Office Action Summary

10/648,464

RALPH ET AL.

DETAILED ACTION

Figure 5 of Xavier et al. '121 is shown below:

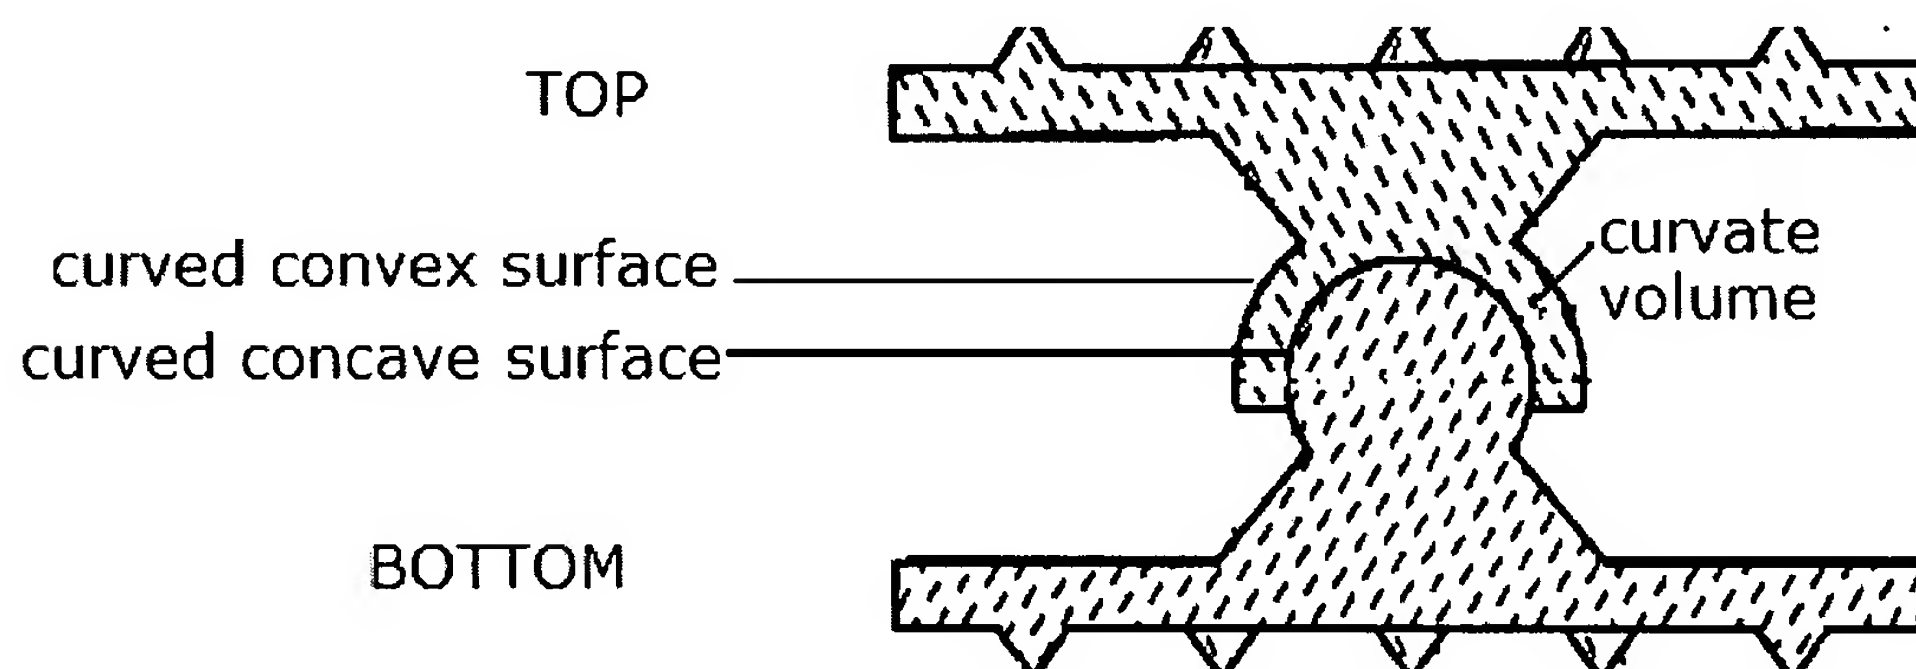
3. Claims 13, 16, 18, 20, 21, and 23 are rejected under 35 U.S.C. 102(b) as being clearly anticipated by Xavier et al. (US 6,063,121 A).
4. As seen in Figures 1-5, Xavier et al. disclose an intervertebral spacer device (10) comprising first (20) and second (48) plate members, each having an external plate surface thereof, wherein an inner surface of one of said plate members comprises a ball-shaped structure (ball supporting member 42 + ball 46, or ball 46 by itself) extending therefrom and an inner surface of the other one of said plate members has a spring (**first interpretation:** socket supporting member 62 and socket 68; **second interpretation:** cushion 80; **third interpretation:** socket supporting member 62 + socket 68 + cushion 80; **fourth interpretation:** socket 68 by itself) affixed thereto, said spring having an opening/curvate volume (**first interpretation:**

socket 68; **second interpretation:** central aperture 90; **third interpretation:** socket 68 + central aperture 90). Xavier et al. disclose socket supporting member 62, socket 68, ball supporting member 42, and ball 46 as made from either metal or ceramic (see column 4, lines 50-64), and able to counteract the load applied to at least one of the plate members (see column 4, lines 11-20). The spring/socket having a top side with a curved convex surface that extends from the curvate volume and confronts (i.e., face) the one of said plates and an underside with a curved concave surface that extends from the curvate volume and is spaced from and confronts (i.e., face) the other one of said plates.

The Applicants argue that Xavier et al. '121 do not disclose newly added limitation: "said spring/socket having a top side with a curved convex surface that extends from the curvate volume and confronts the one of said plates and an underside with a curved concave surface that extends from the curvate volume and is spaced from and confronts the other one of said plates". The Examiner respectfully disagrees. See representation of Figure 5 of Xavier et al. '121 above. It should be noted the language is not specific as to which plates each of the "curved convex surface" and the "curved concave surface" is respectively facing.
